- Request - Special Use Permit for Community Recreation – Active
- Location - 6048 Deer Park Court
- Applicant - Roy J. Cherry  
Epilepsy Center of Northwest Ohio  
1701 Holland Road  
Maumee, OH 43537
- Owner - William Thees  
Professional Offices I Limited  
1909 River Road  
Maumee, OH 43537
- Engineer - George Oravec  
Oravec & Associates, LLC  
5333 Secor Rd, Unit 2  
Toledo, OH 43623

The staff recommends that the Toledo City Plan Commission recommend approval of SUP25-0028, a Special Use Permit for Community Recreation – Active at 6048 Deer Park Court to the Toledo City Council, for the following two (2) reasons:

SPECIAL USE PERMIT  
TOLEDO CITY PLAN COMMISSION  
REF: SUP25-0028  
DATE: September 11, 2025  
TIME: 2:00 P.M.

# SITE PLAN

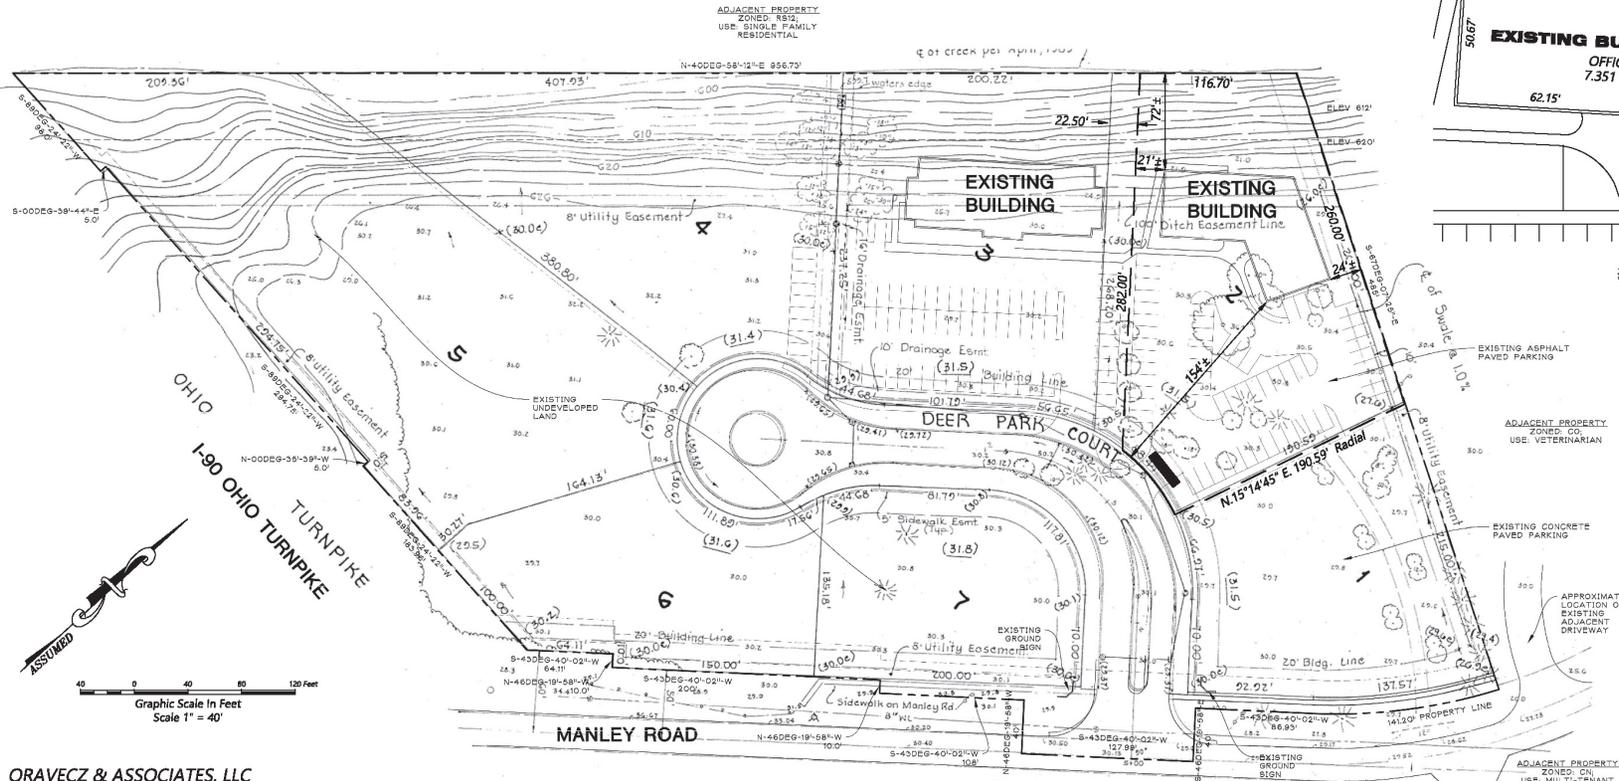
Bicycle parking is required pursuant to Off-Street Parking Schedule “A” (TMC§1107.0300). A minimum of one (1) bicycle space shall be provided per ten (10) automobile parking spaces. Six (6) bicycle spaces are required; however, no bicycle parking is depicted on the site plan. This requirement shall be shown on a revised site plan and is listed as a condition of approval. Pursuant to TMC§1109.0103 - *Connecting Walkways and Pedestrian Connections* must be provided from the main entrance of the building to the street sidewalk. A connecting walkway is not depicted on the site plan. A connecting walkway from the main entrance of the building to the existing street sidewalk shall be provided as a condition of approval and must be shown on a revised site plan.

Pursuant to TMC§1108.0204(C)(1) interior parking lot landscaping is required, and shall consist of two (2) canopy trees and six (6) shrubs for each ten (10) parking spaces to be installed within the parking lot. The site plan depicts an adequate number of trees; however; the proposed locations are not appropriate for maneuverability and internal circulation. The site has three (3) existing trees that may be utilized as credit towards the interior parking lot landscaping requirements. In addition to all other landscape requirements, one (1) two-inch (2") caliper tree for every 1,000 square footage of building coverage; foundation plantings along all portions of the building visible from the right-of-way; and landscaping at the main entrance shall be provided. Furthermore, the site has existing rock within the landscape islands. Per TMC1108.0204(B)(6), this is prohibited; all landscape areas must be covered with hardwood mulch, grass or other vegetative ground cover. The required improvements are listed as conditions of approval and shall be depicted on a revised landscape plan.

16. Any spaces reserved for the use by persons with physical disabilities shall adhere to the standards outlined in TMC§1107.1700. One (1) van accessible space with an eight-foot (8') drive aisle and two (2) car accessible space with five-foot (5') drive aisles are required. **Not acceptable, shall be depicted on a revised site plan.**

17. Bicycle parking slots shall be provided pursuant to Off-Street Parking Schedule "A," (TMC§1107.0300). Minimum number of bicycle parking slots required for Community Recreation – Active is one (1) per ten (10) parking spaces. **Not acceptable, applicant shall provide six (6) bicycle parking slots on revised site plan.**

- a. A fifteen-foot (15') landscaped frontage greenbelt is required along Deer Park Court. At least one (1) tree must be provided for every thirty (30) feet of lot frontage or fraction thereof. **Not acceptable, shall be depicted on a revised landscape plan.**

- c. Interior parking lot landscaping shall be provided, consisting of two (2) canopy trees and six (6) shrubs for each ten (10) parking spaces to be installed within the parking lot. **Not acceptable as depicted, shall be shown on a revised landscape plan.**

- d. Pursuant to TMC§1108.0205, one (1) two-inch (2”) caliper tree for every 1,000 square footage of building coverage; foundation plantings along all portions of the building visible from the right-of-way; and landscaping at the main entrance shall be provided. **Not acceptable, shall be depicted on a revised landscape plan.**
